# FTI-STP1 Automatic Transmission Application Bulletin/Advisory F∥RSTECH

# FTI-STP1: Vehicle Coverage and Preparation Notes

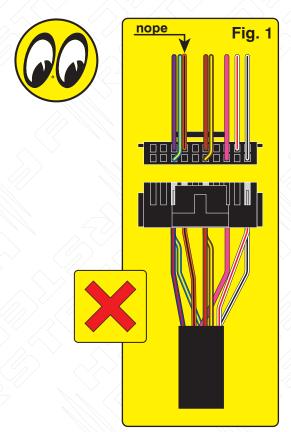
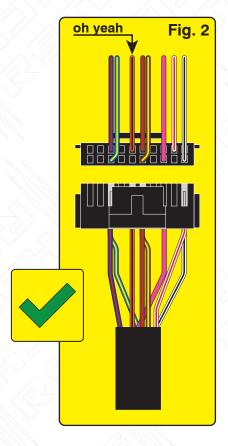
Overview: Production error; immobilizer wire (orange/black) in pin position #4 instead of pin position #5. Although an effort to correct the issue was made, some quantity of harnesses did get shipped before the issue was spotted. We are advising to inspect the harness BLADE connector before attempting to install the harness and program the module.

Issue: Module fails to program to vehicle, will not allow the vehicle to be remote started.

Correction: Step 1.) Locate the orange/black wire and confirm whether it is positioned as illustrated in Fig. 1 or Fig. 2. If the wire is as illustrated in Fig.1, proceed with Step 2 through 5 and complete the repair procedure outlined, if the wire is as illustrated in Fig. 2, correction is not necessary, proceed with harness installation and module programming.

- Step 2.) Using a pick, lightly depress the catch that secures the terminal in the housing then remove the wire and terminal from the housing.
- Step 3.) Using a fine tip razor or utility knfe, inseret the blade beneath the terminal catch and raise it slightly, so that it can be reused to secure the terminal when reinserted into the BLADE connector housing.
- Step 4.) Refer to Fig, 2 for correct position of the orange/black wire (next to brown/red) then reinsert the terminal, pressing lightly until the catch 'snaps' into place, securing the terminal in the connector housing.
- Step 5.) The repair is complete, proceed with installation and programming.

#### **Automatic Transmission Application I/O Changes:**

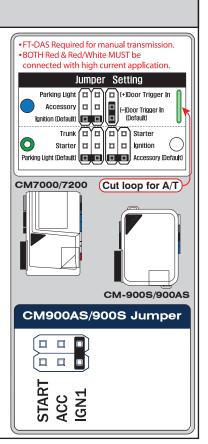
**Issue:** The FTI-STP1 T-harness has been designed to be compatible with AT (automatic transmission) & MT (manual transmission) applications, but due to a production oversight, the selection mechanism was defaulted to MT mode.

Using a harness configured for an MT application, in an AT equipped vehicle, could result in vehicle module damage, it is advised that the harness be returned to AT mode before installation in vehicles equipped with an automatic transmission.

**Correction:** Locate the **red/black** (+ Clutch) wire provided in the CN1 connector of the main harness assembly. Cut the **red/black** wire, either flush to the CN1 connector, or leaving enough wire exposed so that you can insulate and secure the ends of the wire that remain after cutting. Insulate each of the remaining ends of the **red/black** wire and secure to prevent any possibility of a short circuit.

If the red/black wire already been disconnected, no further modification is required for AT equipped vehicles.

CMX, CM7, and CM9 Series controllers: No configuration changes required. See previous page for modification required at the CN1 connector parking light (+ clutch) output position.
